OBJECTION TO 26/00774/FP

Andrew Hills ARB, Owner 13 Conquest Close

18/05/26

FIG 1.0 Boundary of Development Site as per Land Registry Jan 2018

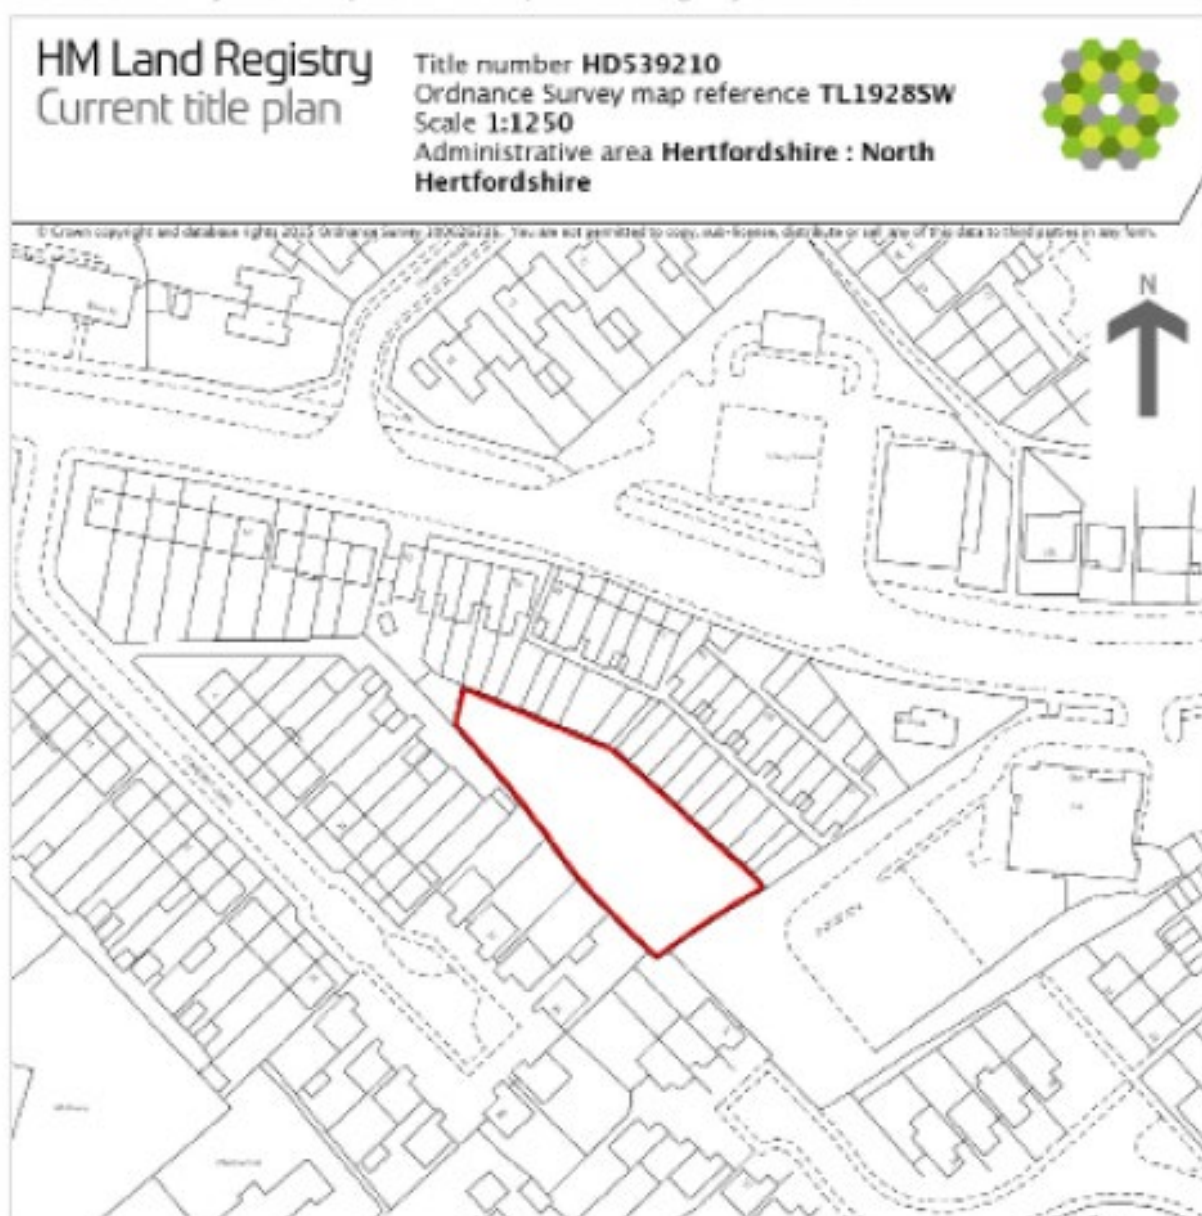
The entire access road from the rear of number 21 up to the point where the access road adjoins Conquest Close falls outside the ownership of the applicant and is divided between a number of neighbouring properties (approx 10+). The ownership boundary is therefore distinctly different from the planning application boundary indicated in the proposed drawings. Refer to fig 1.0 which indicates the ownership boundary as currently recorded in land registry documents.

It should also be noted that removal of the existing hedges to create vehicular access to the properties from the laneway is also likely to require the agreement of the relevant landowners as deeds suggest the boundary hedges flanking the laneway fall within the ownership of properties along Conquest Close. The proposal currently proposes the removal of hedges in their entirety to the rear of numbers, 17, 19 and 21

House Waste Site Plan As Proposed

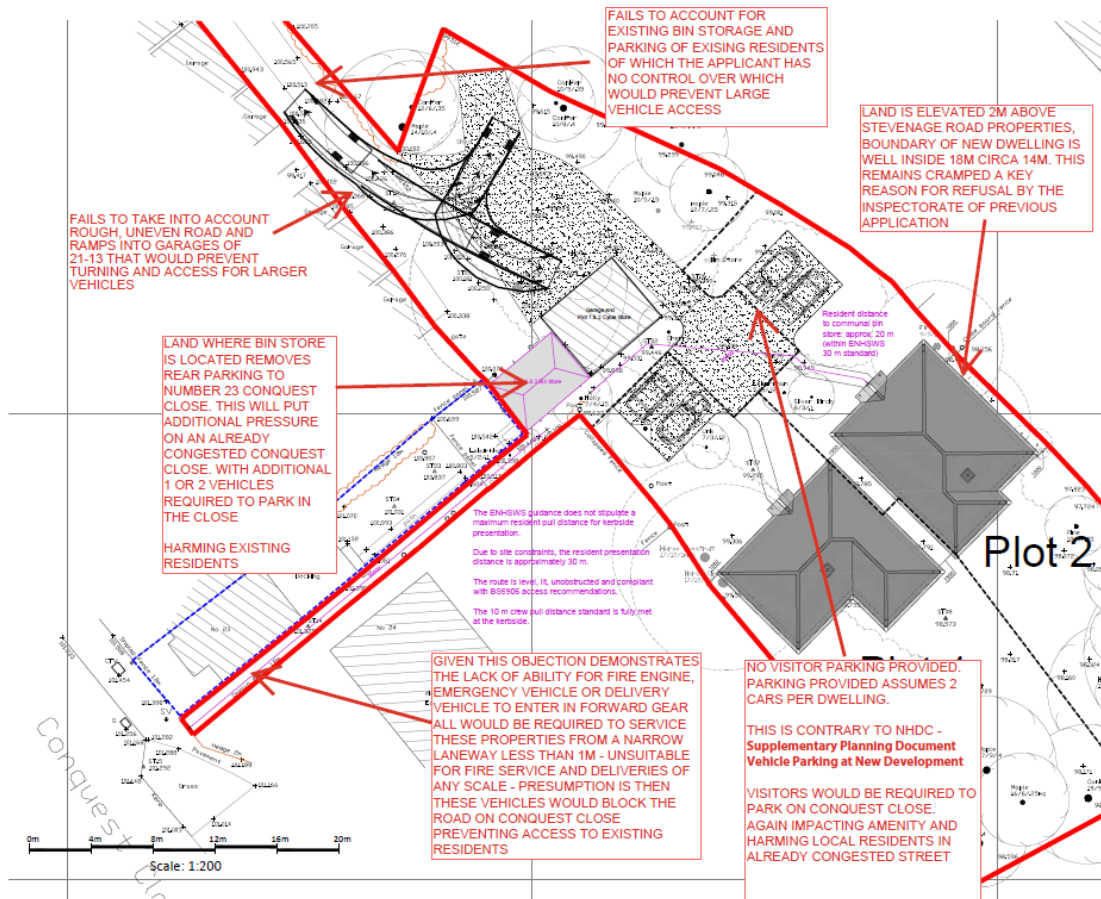
In contrast the current access way is located on the inside of the curve on Conquest Close and visibility is severely restricted by on street parking and bin storage. The proposed site plan provides a limited swept path diagram focussed on the end of laneway, it fails to take into account the on street parking conditions which restrict the view from the entryway and narrow the width of the entire laneway and Conquest Close itself. Therefore it is highly

unlikely that the swept path indicated can regularly be achieved as the vehicle would be unable to access the site.

The provided swept path analysis is limited to the end of the access lane only and fails to take into account the transitory route required to reach the dwellings, on street parking and day to day use of the laneway by residents. The drawing provided is not a detailed survey and does not provide accurate dimensions that identify the laneways significant pinch points.

Swept path studies do not show reality of congestion in Conquest Close. Parked vehicles obscure the entrance / exit. Making it difficult for larger vehicles to enter and exit and dangerous for pedestrians
